RESOLUTION NO. 2022-27

**AN AMENDMENT TO THE ROAD AND SUBDIVISION POLICY
REPLACING EXISTING TYPICAL RIGHT OF WAY ROAD
SECTIONS AND ADDING ADDITIONAL SECTIONS**

The typical right of way sections found on pages 69, 70 and 71 of the Road and Subdivision Policy shall be deleted and the following right of way sections, attached hereto, shall be added in their place:

TYPICAL 80' RIGHT-OF-WAY SEALCOAT MAINTENANCE SECTION

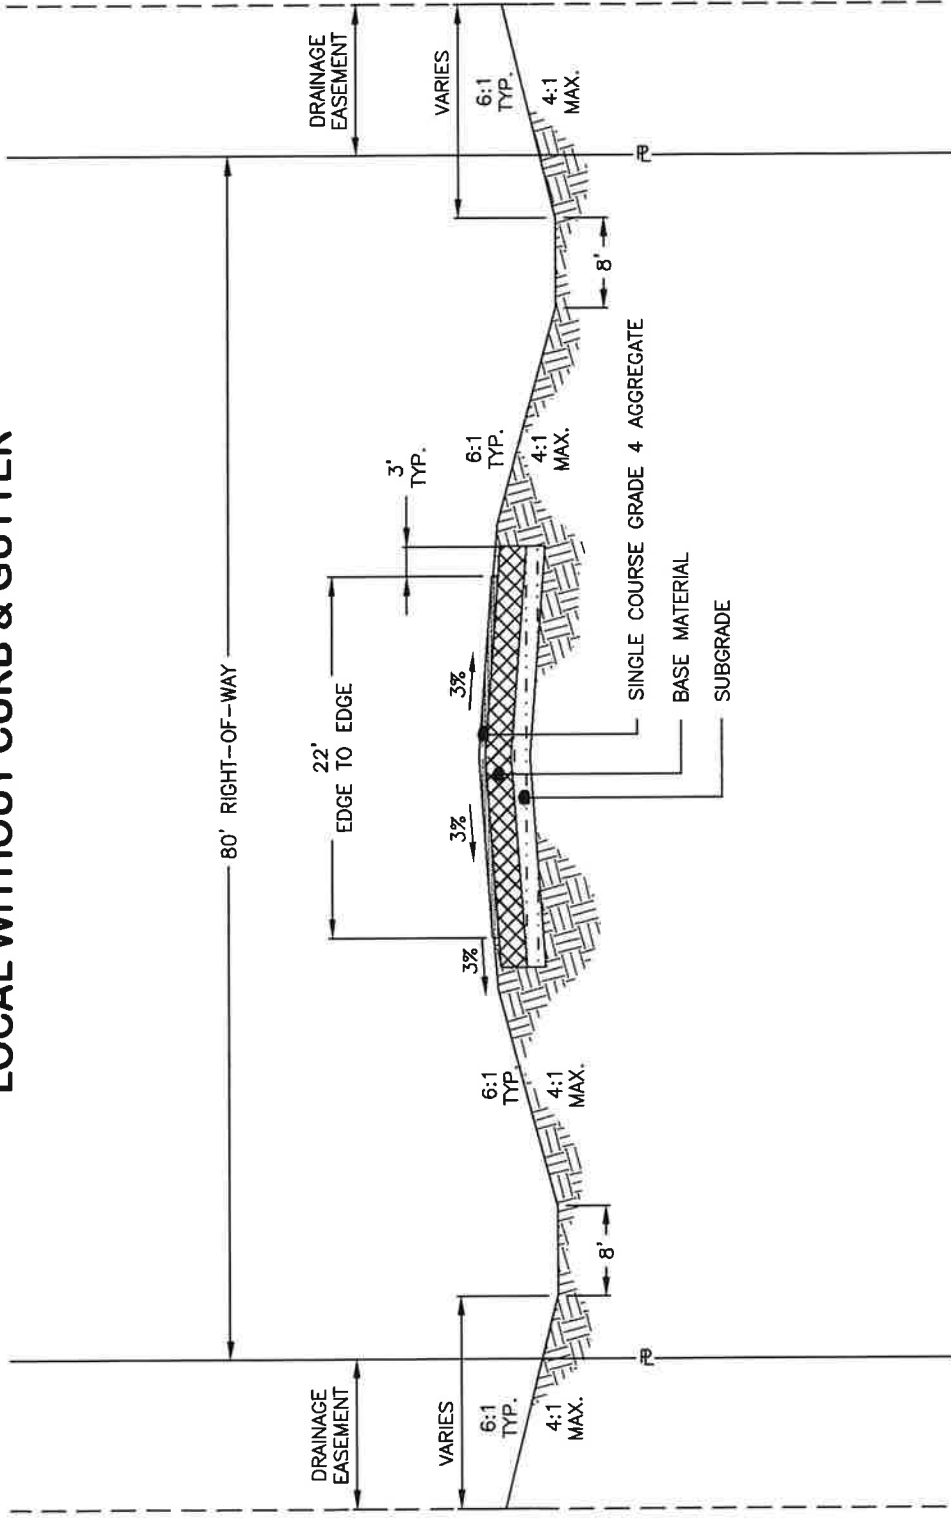
- Exhibit A – Typical 80' Right-of-Way Sealcoat Maintenance Section;
- Exhibit B – Typical 60' Right-of-Way Curb & Gutter Street Section;
- Exhibit C – Typical 80' Right-of-Way Curb & Gutter Street Section;
- Exhibit D – Typical 80' Right-of-Way Road Section;
- Exhibit E – Typical 100' Right-of-Way Curb & Gutter Street Section;
- Exhibit F – Typical 100' Right-of-Way Road Section; and
- Exhibit G – Typical 120' Right-of-Way Road Section.

To the extent the specifications contained in these exhibits conflict with the requirement in the Policy of a minimum of one and one-half (1½) inches of asphalt paving on all new paved surfaces, the specifications in these exhibits shall prevail.
